**Development Referral No. DN14/0007**

**Proposal: Section 75W Modification (MOD 3) to Concept Plan for Kirrawee Brick Pit (MP10\_0076) - Modification of Approved Envelopes**

**Property: 566-594 Princes Highway, Kirrawee**

**Figure 1: Portrayed heights of approved buildings (Flora Street elevation)**

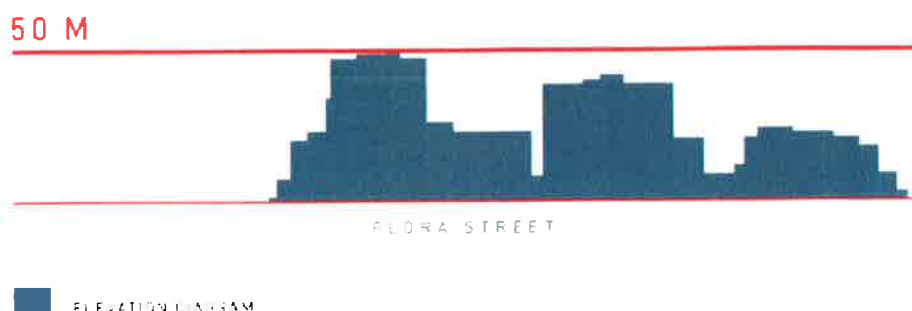
This diagram is misleading as it is not a true representation of the approved heights of buildings that front Flora Street. The tallest of the buildings shown are in fact centrally located on the site and as such will be visually recessive and not read from Flora Street. Figure 4 below is considered to be a more accurate representation of the heights of the approved buildings that front Flora Street. The impacts to Flora Street of increasing these 5 and 6 storey buildings to 8, 11 and 14 storeys have largely been ignored within the application.

The impact of increased building heights upon future developments on Flora Street should be demonstrated. It is unclear if the proposal will allow sufficient solar access (compliant with SEPP65) to be achieved by future developments on the southern side of Flora Street.
